PLAN OF PROPOSED IMPROVEMENT

HILL VALLEY - PHASE 1

CITY PROJECT NO. 15668
CONTRACT NO. 9643

REVISION 1 - 9/ 17/ 2025

5668 P-2

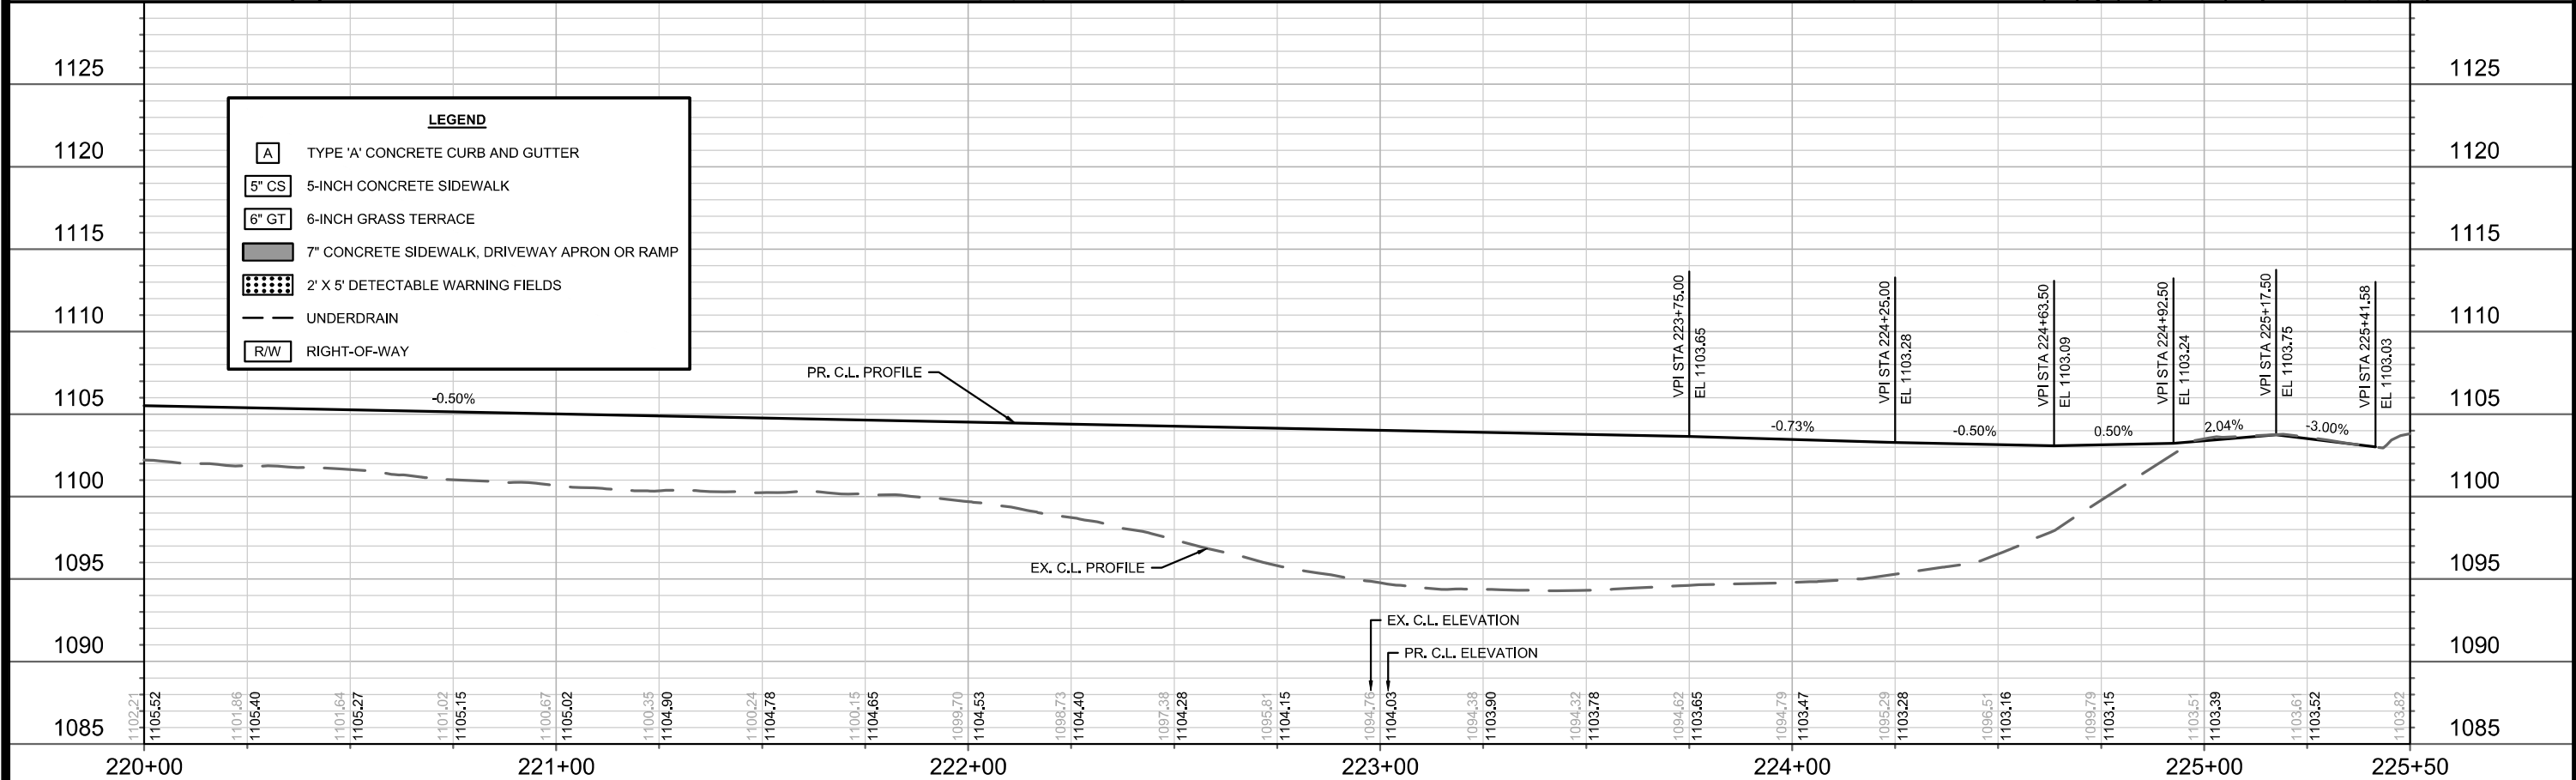
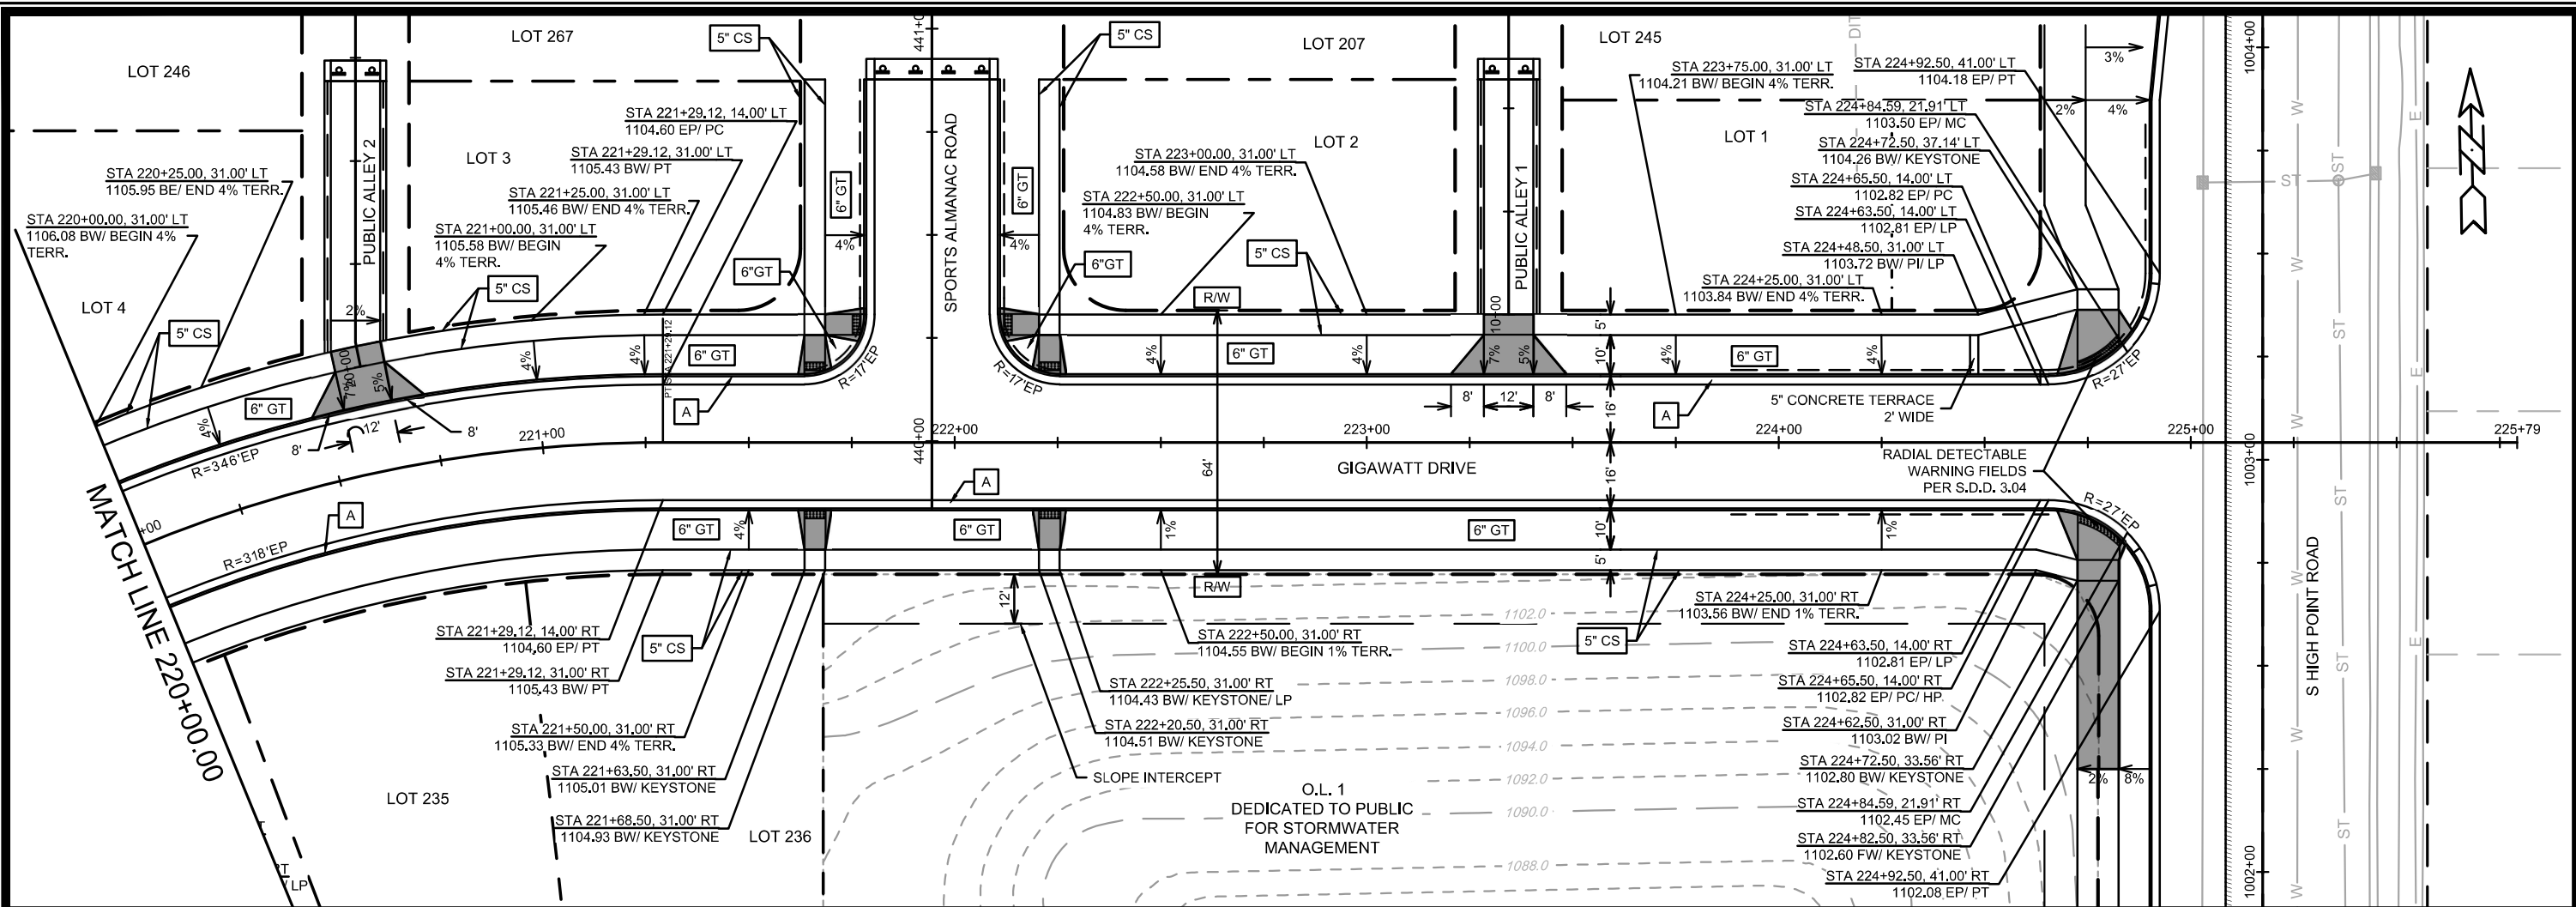
REVISION 1 - GCIT
REPRINTED TO SHOW
ACCESS PATH ON O.L. 1

P-7

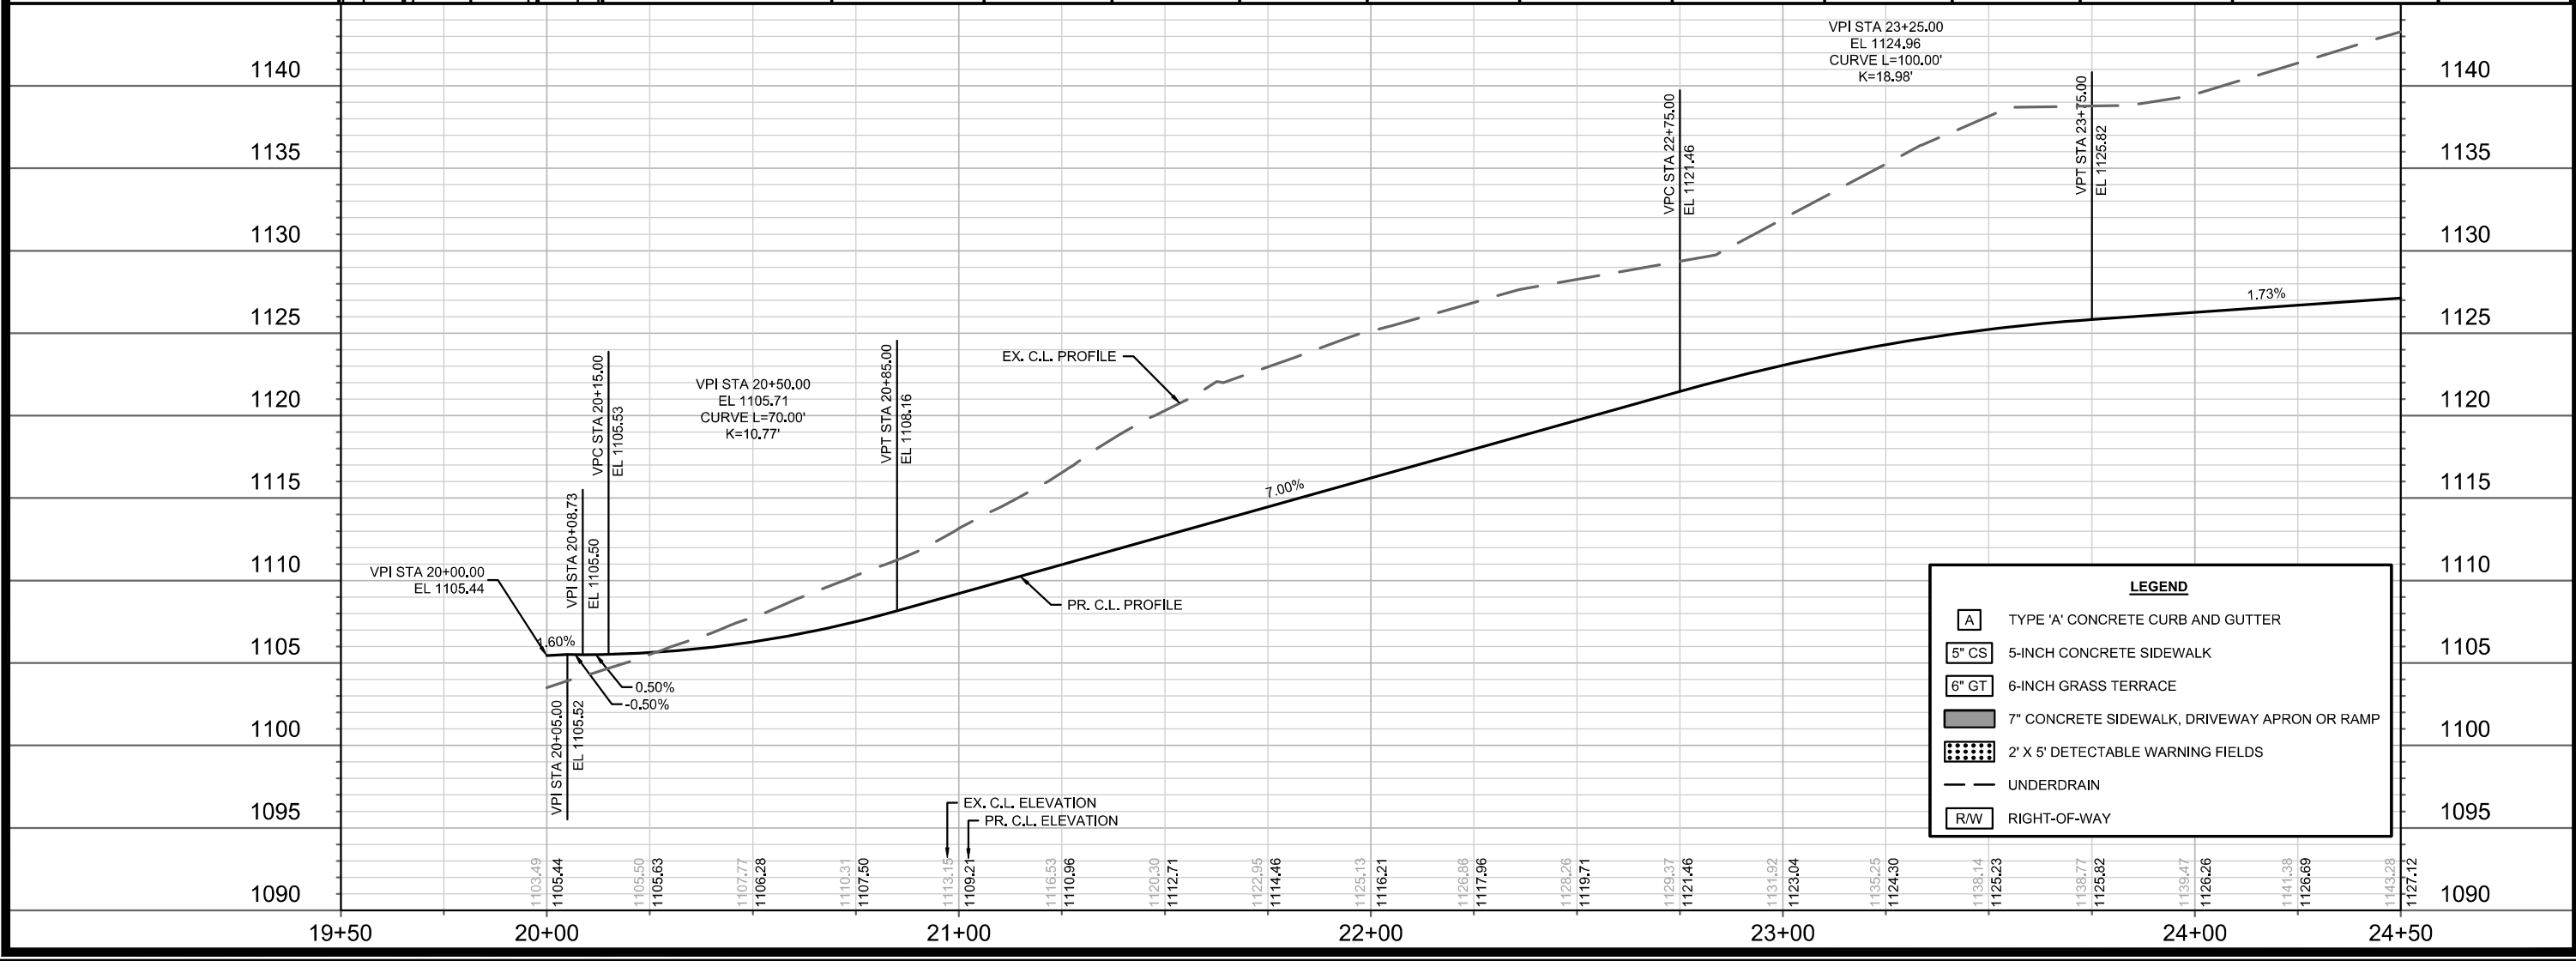
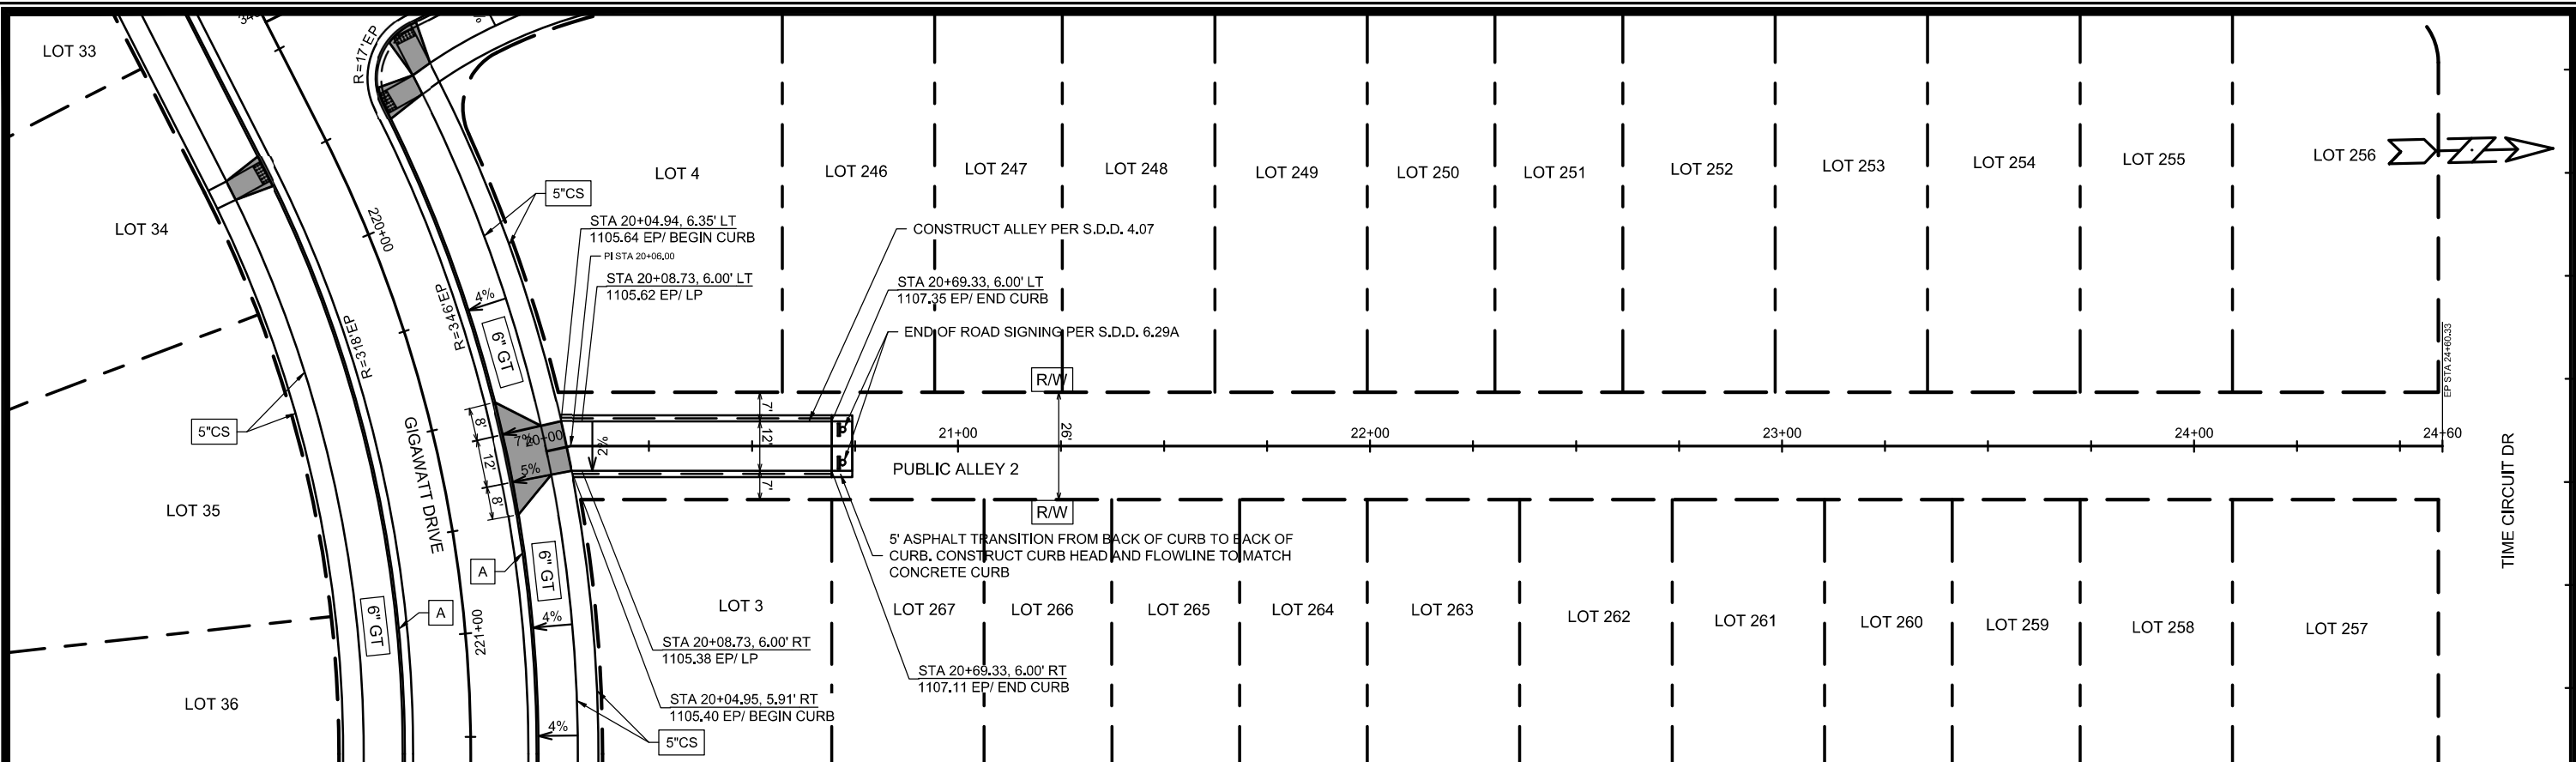
REVISION 1 - GCIT
REPRINTED TO SHOW
ACCESS PATH ON O.L.1
